**NOTICE OF DECISION TO CONSENT TO CHANGE TO PROPOSAL DURING  
ASSESSMENT**

Mardie Project  
Assessment No. 2167

**STATEMENT OF REASONS**

**Proposal:** Mardie Project (Assessment Number 2167)

Figure 1 – Changes to Development Envelopes

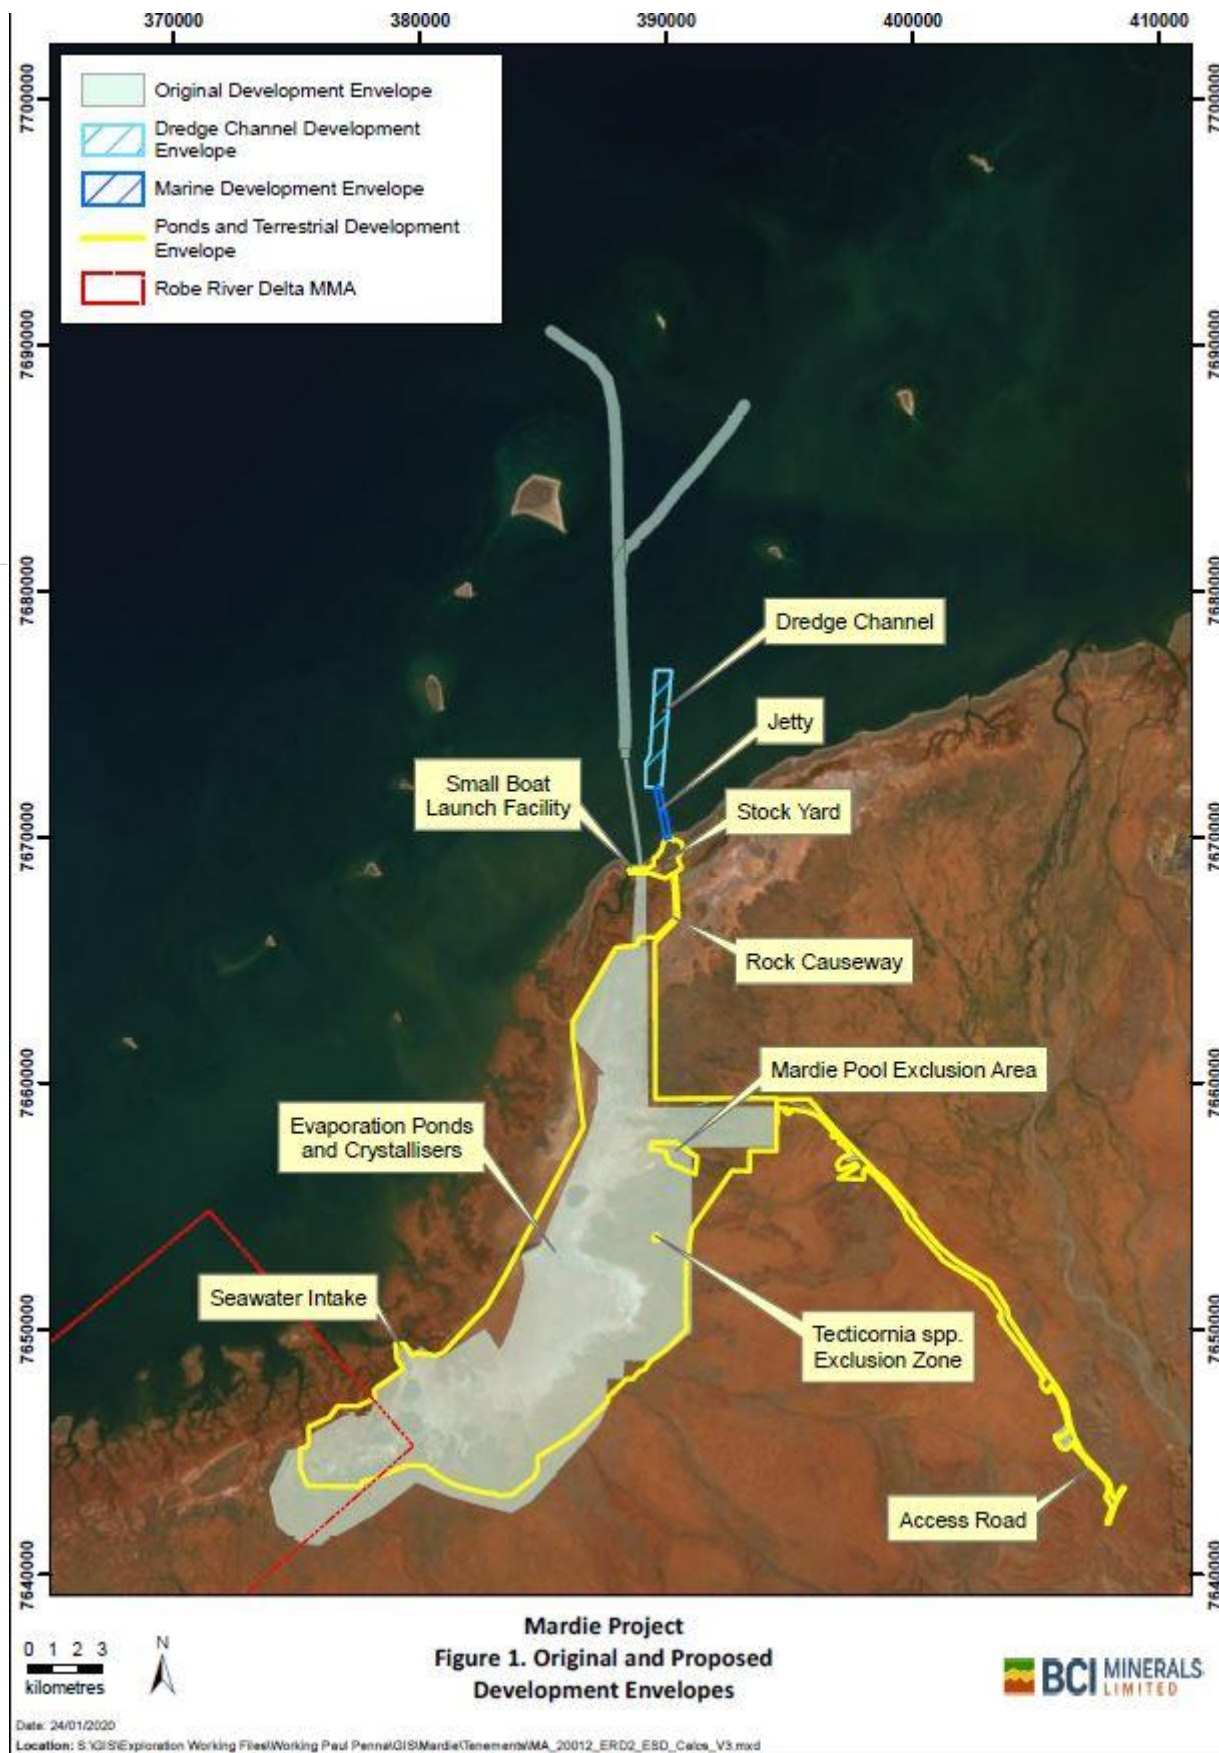
- Revision of proposed development envelopes as described in Schedule 1 and Shown in Figure 1 of Attachment 1
- Change to project disturbance footprint as described in Schedule 1 and Shown in Figure 2 of Attachment 1
- Increase in total terrestrial disturbance footprint, including addition of port stockyard and small boat launching facility.
- Decrease in direct impacts to marine environment from marine jetty and bitterns infrastructure, and re-alignment of marine infrastructure.
- Changes to proposed dredging operations, including reduction in direct dredge area, increase in dredge volume, and re-alignment of dredge channel.
- Realignment and replacement of intertidal trestle jetty with a rock causeway.
- Additional lighting on coastal areas.

Table 1 presents the changes to the proposal. Figure 1 presents the changed development envelopes, and Figure 2 presents the changed conceptual footprint.

The proponent has revised the development envelopes for the proposal, resulting in a total reduction of the development envelopes by 913 hectares (ha) from 16,937 ha to 16,024 ha.

The changes to the development envelopes include:

- Realignment of the intertidal crossing further to the east. As discussed previously, this change would result in a reduction in impacts to significant mangrove communities.

- Exclusion of environmentally sensitive areas including Mardie Pool and significant flora species from the development envelopes. This change would result in a reduction in impacts to significant species and cultural areas.

- Moving some intertidal areas from the marine envelope to the ponds and terrestrial envelope. This change would not result in any changes to the location or extent of the disturbance footprint.

- Expanding areas in the north of the project area to include port and boat launching areas. This change has the potential to impact different vegetation types to that of the original proposal, including the locally significant AcAjTe Soak vegetation type. As discussed previously, this vegetation type would be avoided until it can be identified outside the development envelopes.

- The re-alignment and reduction of the marine infrastructure and dredge envelopes. This change has the potential to impact different BCH types to that of the original proposal. As discussed previously, the re-alignment away from islands known to be associated with significant BCH types has the potential to reduce impacts to significant BCH.

Figure 1 – Overview of proposed changes

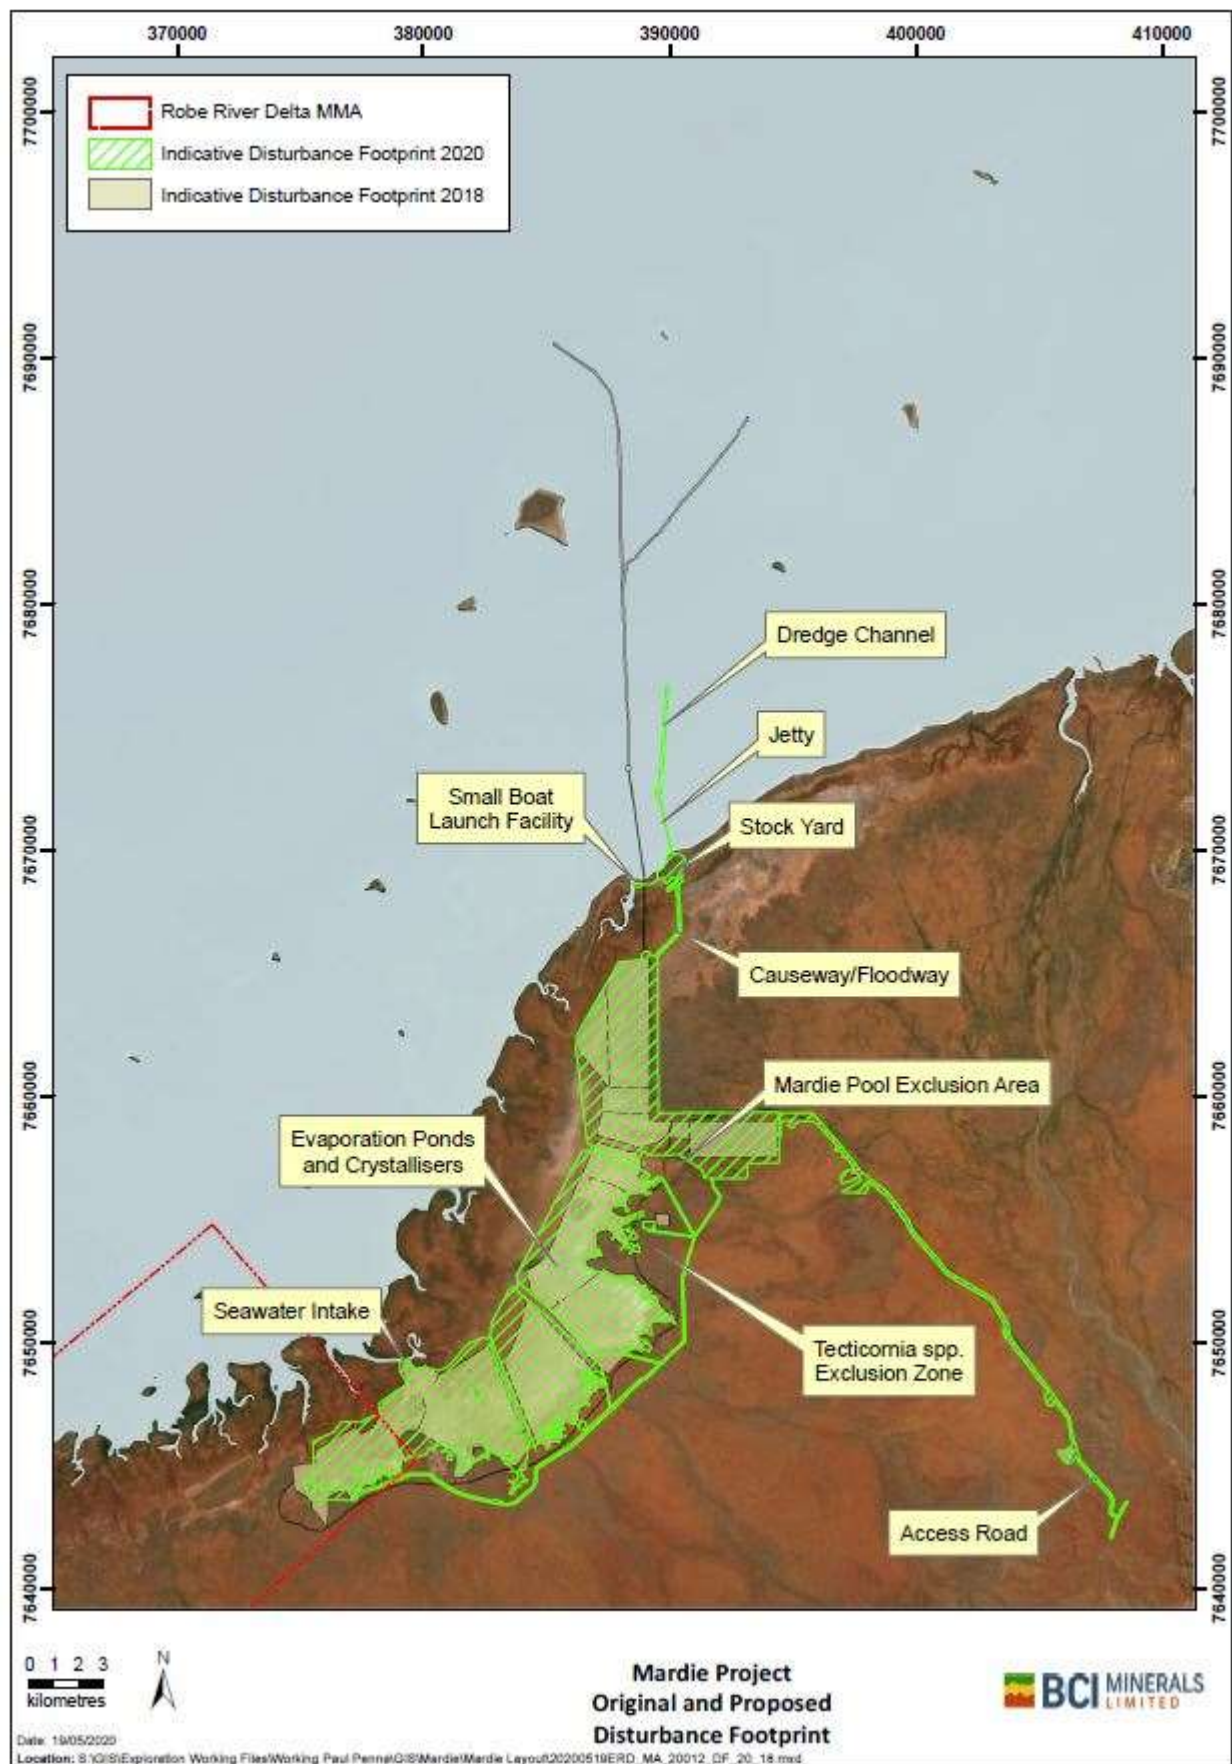
The original proposal included direct disturbance of up to 9,551 ha, including direct disturbance for ponds, terrestrial infrastructure, marine infrastructure and dredging. The revised proposal includes up to 11,221 ha of direct disturbance (additional indirect disturbances are addressed below). This is an increase of 913 ha (17.5%) (Figure 1).

Figure 2 – proposed additional port areas and AcAjTe (Soak) vegetation type

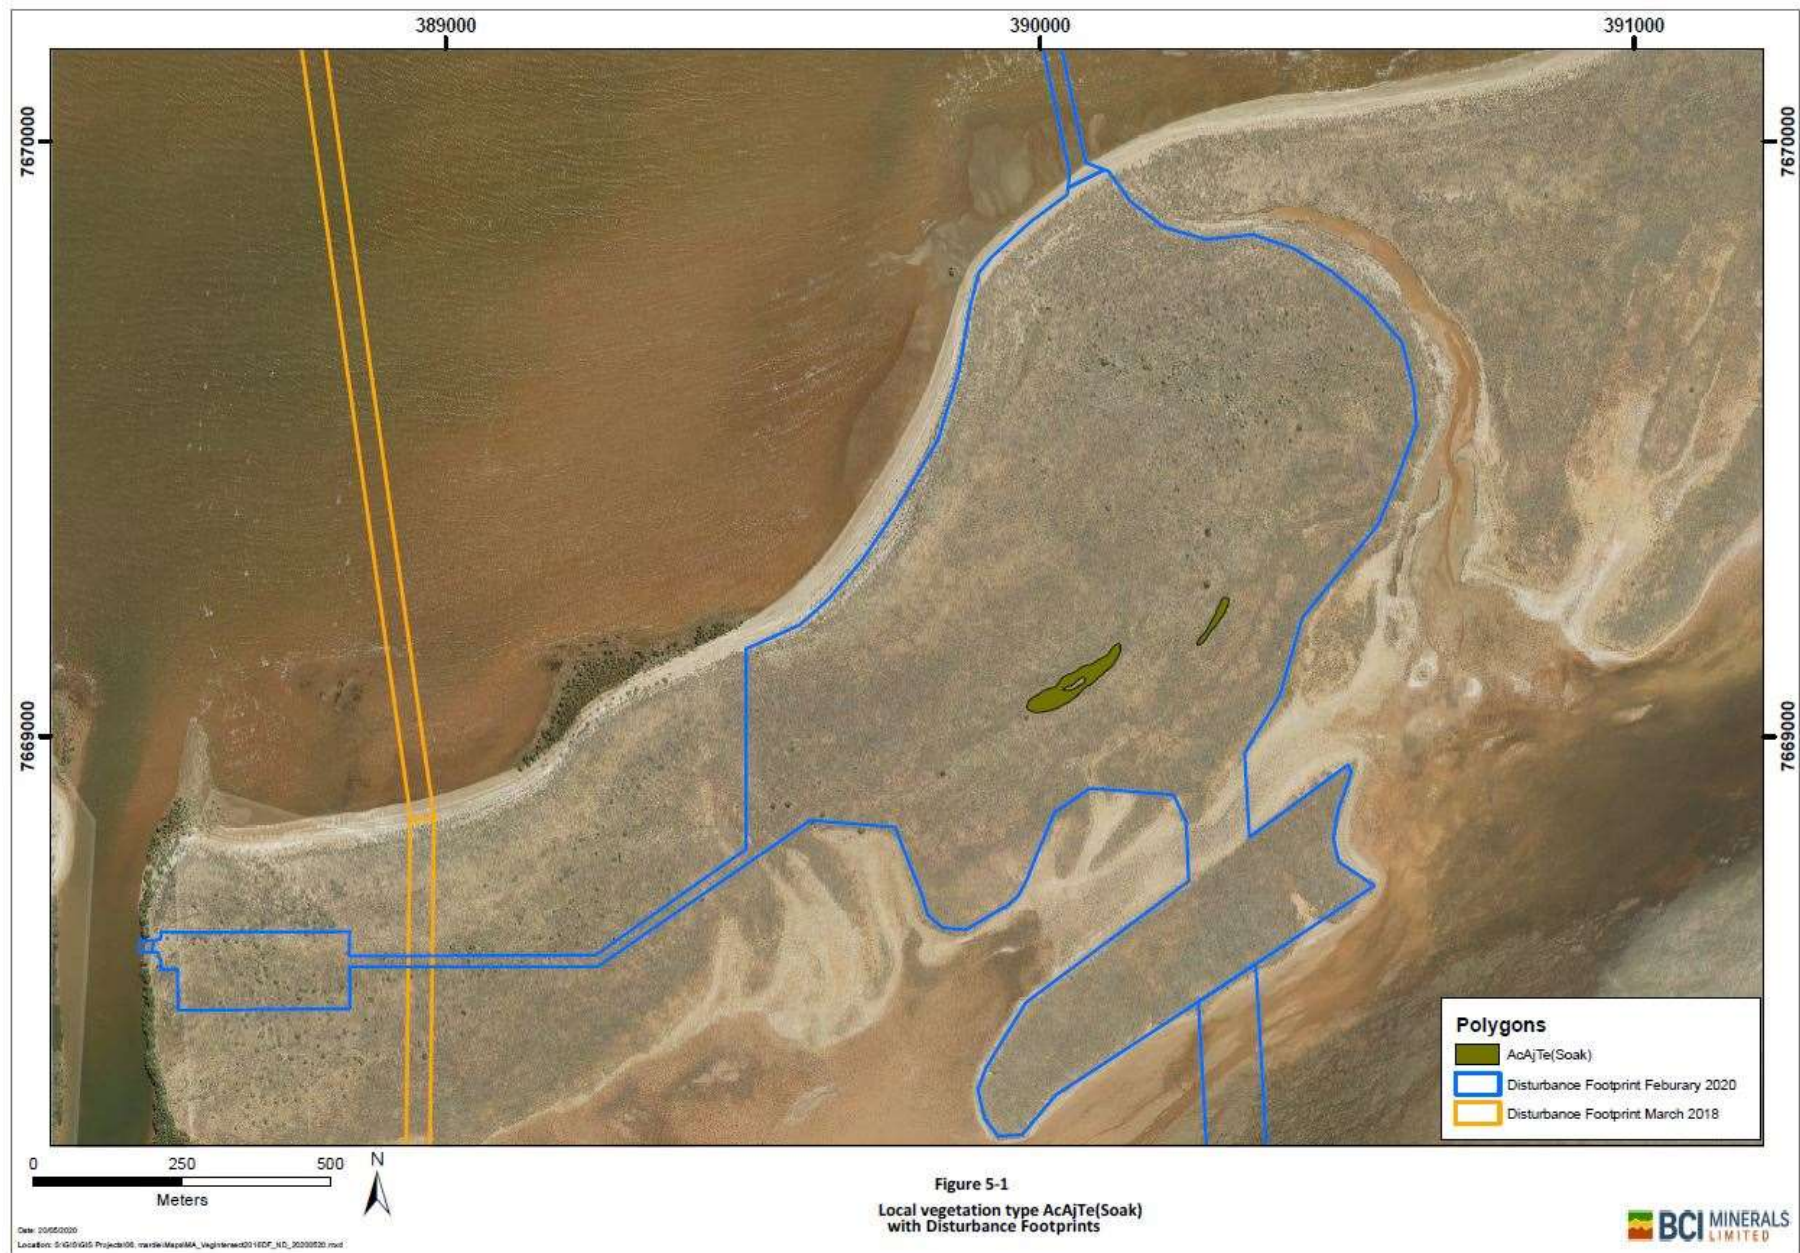
- Decrease in impacts to mangroves from 25.2 ha to 17 ha.
- Additional disturbance to the Algal mat from 457 ha to 880 ha (92%). Most of this change is related to an increase in the disturbance associated with evaporation ponds.
- Increase in direct impacts to coastal vegetation from 4.4 ha to 96 ha as a result of the inclusion of the port stockyard and boat launching facility.
- Increase in impacts to the AcAjTe Soak (locally significant) vegetation type from 0 to 0.6 ha, representing the entirety of the currently mapped extent of this vegetation type. The proponent notes that this vegetation type is likely to be identified elsewhere with further study, and will be avoided until additional areas can be mapped outside of the development envelope (Figure 2).

- The total increase in disturbance of 17.5% is considered to be relatively small.
- The addition of the port stockyard and boat launching facility, totalling 96 ha, is relatively small in the context of the proposal.
- The AcAjTe Soak vegetation type would be avoided unless identified outside the development envelope.

Figure 3 – Changes to impacts on BCH (Marine)

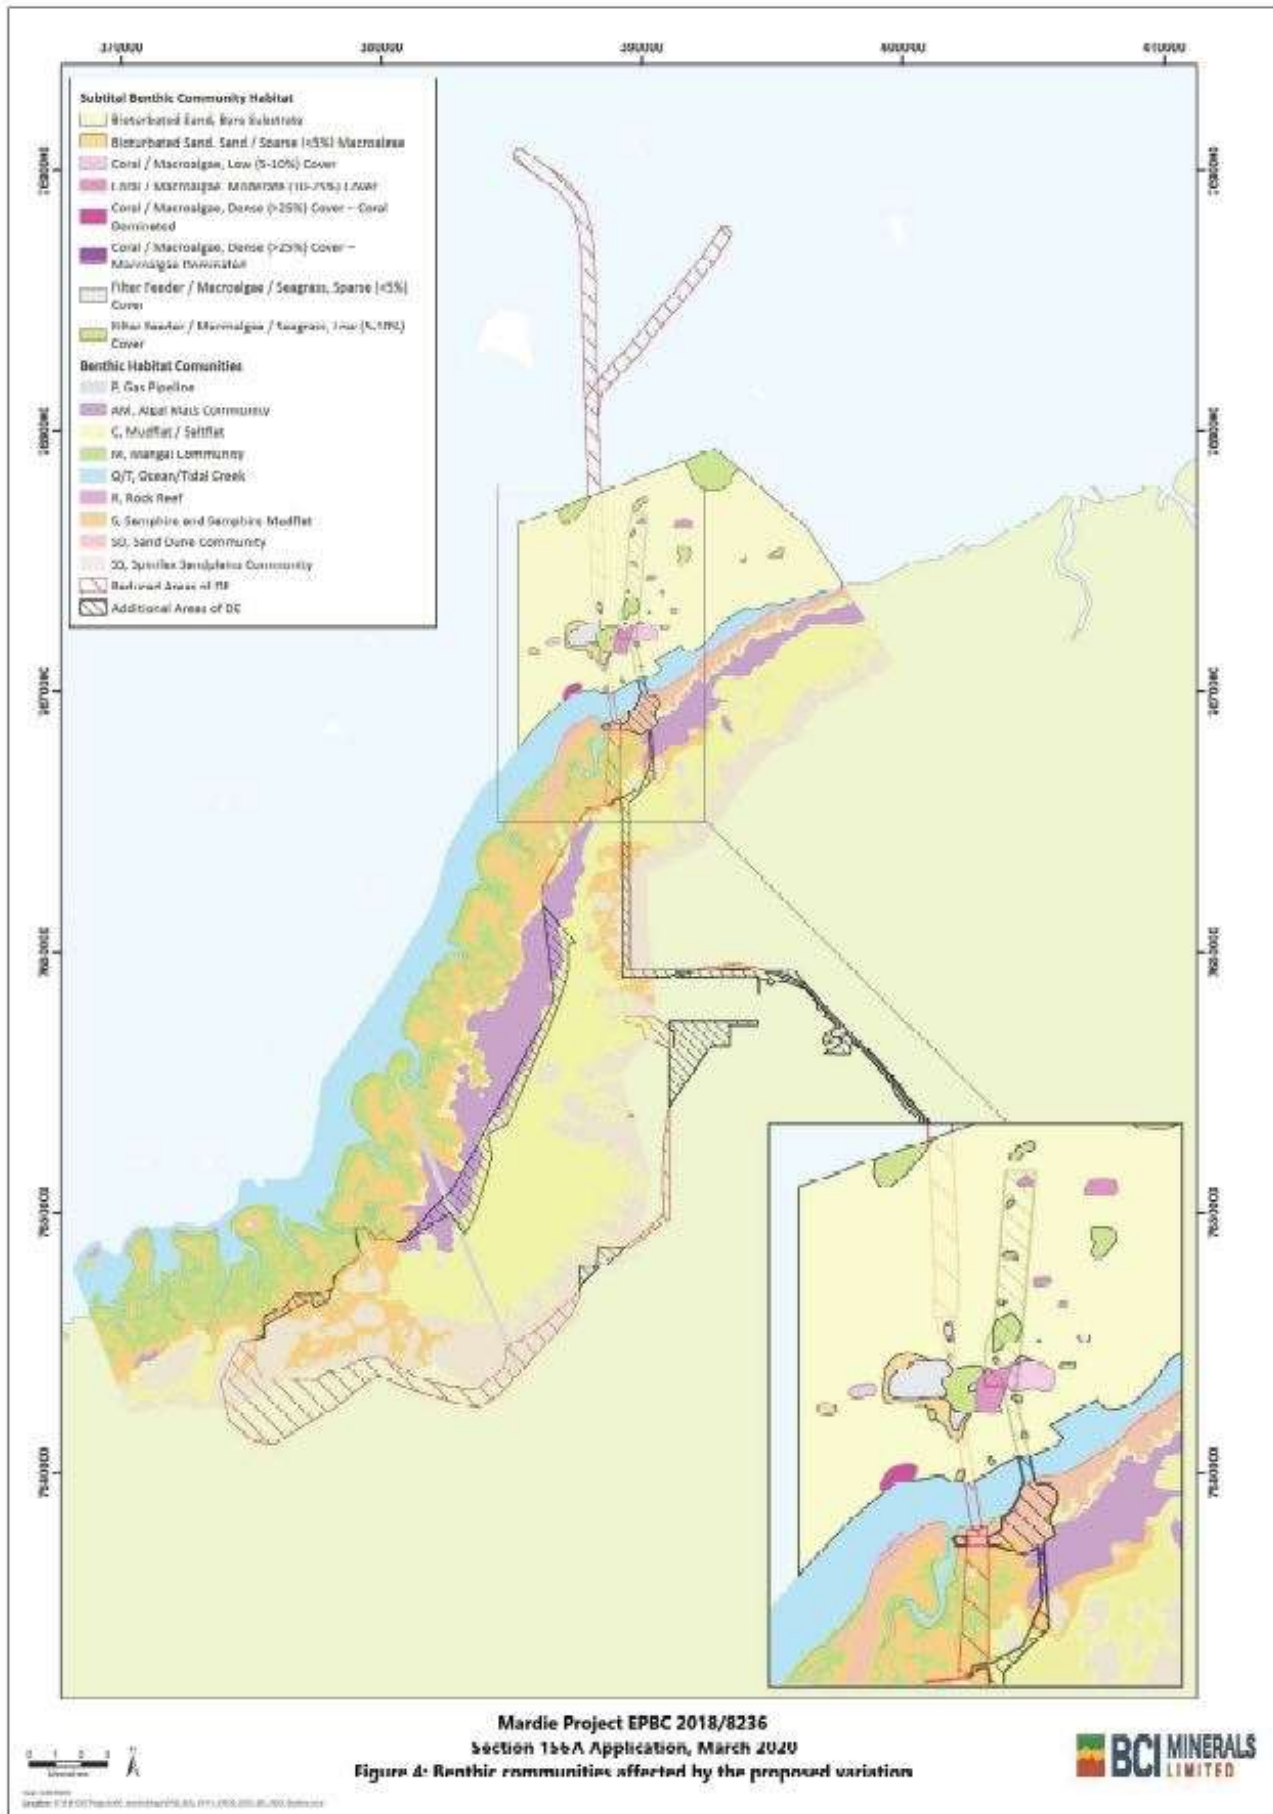
The direct footprint of the marine jetty and bitterns outfall infrastructure would be reduced from 22 ha to 7 ha. Note that the jetty and marine infrastructure areas are represented by the thinner, landward portions of the respective envelopes shown in Figure 3.

The re-alignment of the infrastructure could change the composition of BCH types that would be impacted. No quantification of impacts to individual BCH types is available, however Figure 3 indicates minimal change to significant BCH types.

**These changes are unlikely to significantly increase any impact the proposal may have on the environment** because the change to direct disturbance is reduced, and the change to the composition of BCH types that would be impacted does not appear to be significantly different, based on habitat mapping provided in Figure 3.

- There would be a decrease in direct impacts to marine BCH associated with the dredge channel from 146 ha to 55 ha. (Figure 3).
- There would be an increase in dredging volume from 500,000 m<sup>3</sup> to 800,000 m<sup>3</sup> (60%). The proponent has indicated that this change is the result of improved knowledge of bathymetry and sub-sea geology, and should be considered in conjunction with the reduced dredging footprint.

- Re-alignment of the dredge channel could change the composition of BCH types directly impacted. As BCH mapping was not conducted for the entirety of the original proposal (Figure 3), it is not possible to quantify this change to the proposal, however it is reasonable to consider that the impacts to significant BCH types would be reduced in this instance, given the size of the original footprint.
